| <b>Delegated Report</b>  |                            | <b>Analysis sheet</b>   |                                     | <b>Expiry Date:</b>              | 26/03/2020 |
| Sofie Fieldsend  |                            |                         | 2019/6302/HS2                       |                                  |            |
| Submission under Schedule 17 of High Speed Rail (London - West Midlands) Act 2017 for plans and specifications for the excavation of a railway cutting involving erection of retaining walls with concrete parapets on top between Hampstead Road Bridge and Granby Terrace Bridge adjacent to the existing West Coast Main Line (to the east) |                            |                         |                                     |                                  |            |

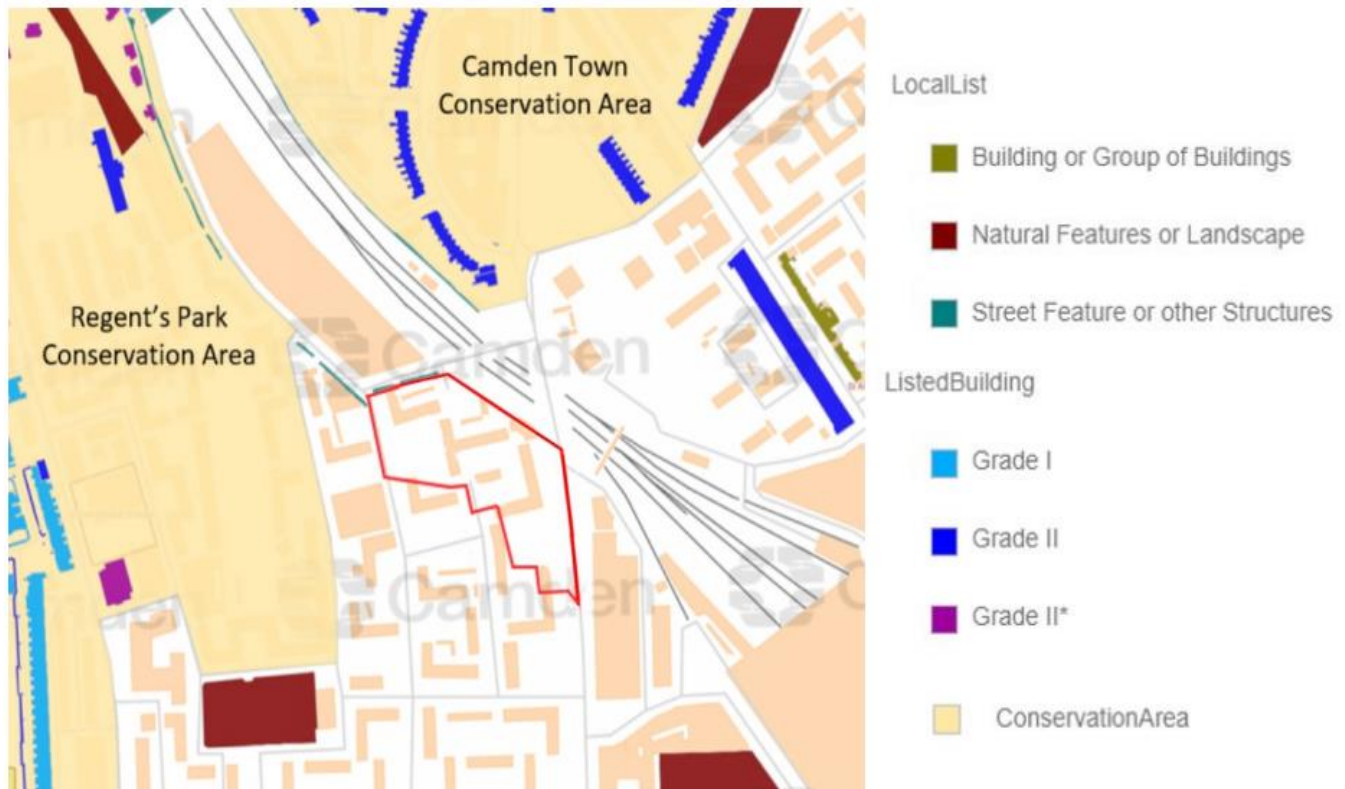
- 6.1 While the site is not within a Conservation Area, it is adjacent to the Regent's Park and Camden Town Conservation areas, the former of which would be affected by views from and to the development (shown on the map below). Camden Town CAAC objected to the design/appearance, impact on views into/from the conservation area, lack of biodiversity and that the art opportunities are not suitable as they could result in graffiti.

6.2 Concerns were also raised that the development would impact on the listed buildings in close proximity. It is noted that the closest Grade II listed buildings are found on the eastern side of the railway line along Mornington Crescent (listed buildings shown in blue). It is considered the rear of these properties already overlook the existing cutting and the development to extend this on the land on the other side of the cutting would not cause detrimental harm to their setting or significance and would have a similar but acknowledged slightly worse outlook to the existing view but not to the extent that would warrant a reason for refusal. The other listed buildings near the site are considered to be a sufficient distance away from the development or screened behind existing townscape. The grade II\* listed Nash-designed houses at the northern end of Park Village East are a sufficient distance away not to have their setting affected. However, it is noted that the wall may be visible in long views along Park Village East from outside these houses.

6.3 The impact on the Regent's Park Conservation Area is more immediate as its eastern boundary is only some metres away from the western section of the proposed wall. Although there are some housing blocks situated between the application site and the wall, its notable height, solid appearance, and insensitive and brutal use of concrete which is out of keeping with the materials and colours and finishes of buildings which are predominant in the conservation area, will be visible from the eastern section of the conservation area and impact on immediate views out of the conservation area. It will also provide an oppressive and overbearing sense of enclosure within a short distance of the conservation area boundary, impacting to a limited extent on its setting. The proposed structure will also be visible from the section of the conservation area to the north in Park Village East (including the stretch further north where the grade II\* listed residential properties are situated). The overbearing nature of the wall by way of its height, solidity and use of materials will have a notable impacting on the vista out of the conservation area looking south. Likewise, there will be a low-level impact on the setting on the conservation area due to its prominence in close proximity to its boundaries which is going to affect a limited number of shorter distance views into the conservation area.
